Access Compliance Report

Public Rights-of-Way

(Curb Ramps)

Intersection ID: 16359	Main Street: FREELAND_LN	Cross Street: SOUTH_BV	Location: NW
ADA ID: B0013439151D	Ramp Type: PerpDiag	Initial Pass/Fail: Fail	Overall Compliance: No Severity Score: 13.75

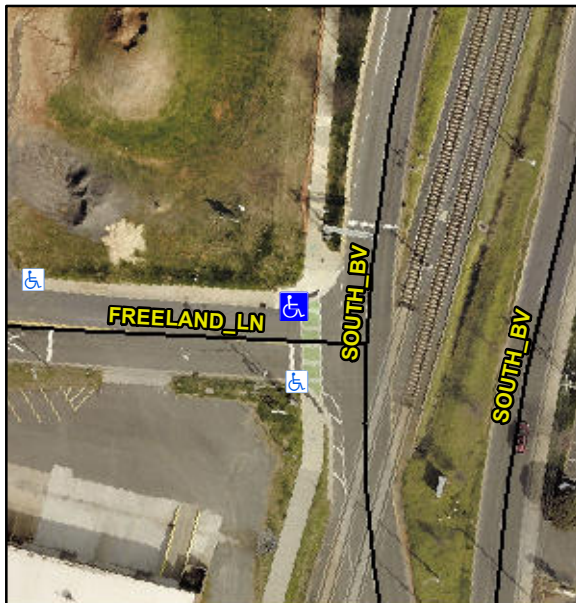
R304.2.2, R304.5.3

Compliance	Description	Data	Compliance	Description	Data
N/A	Ramp Length (in)	60.0	No	Ramp Slope (%)	8.6
Yes	Ramp Width (in)	119.0	No	Ramp XSlope (%)	4.3
N/A	Flare Type LT	N/A	N/A	Flare Type RT	N/A
N/A	Flare Slope LT (%)	N/A	N/A	Flare Slope RT (%)	N/A
N/A	Flare Traversable LT?	N/A	N/A	Flare Traversable RT?	N/A
N/A	Landing Length (in)	N/A	N/A	DWS Provided?	N/A
N/A	Landing Width (in)	N/A	N/A	DWS Contrast?	N/A
N/A	Landing Slope (%)	N/A	N/A	DWS Length (in)	N/A
N/A	Landing X Slope (%)	N/A	N/A	DWS Full Width?	N/A
N/A	Landing Curb? (Y/N)	N/A	N/A	DWS Offset (in)	N/A
N/A	Shared Landing?	N/A			
N/A	Gutter Ponding?	N/A	N/A	Gutter Slope (%)	N/A
N/A	Gutter Lip Ht (in)	N/A	N/A	Gutter X Slope (%)	N/A
N/A	Painted X Walk1?	Yes	N/A	Painted X Walk2?	No
	X Walk 1 Direction	To S		X Walk 2 Direction	To E
N/A	X Walk 1 Width (in)	106.0	N/A	X Walk 2 Width (in)	N/A
	X Walk 1 Slope (%)	0.2		X Walk 2 Slope (%)	2.5
	X Walk 1 X Slope (%)	4.1		X Walk 2 X Slope (%)	0.0

Remove & Replace Curb Ramp With Two New Directional Ramps or Equivalent.
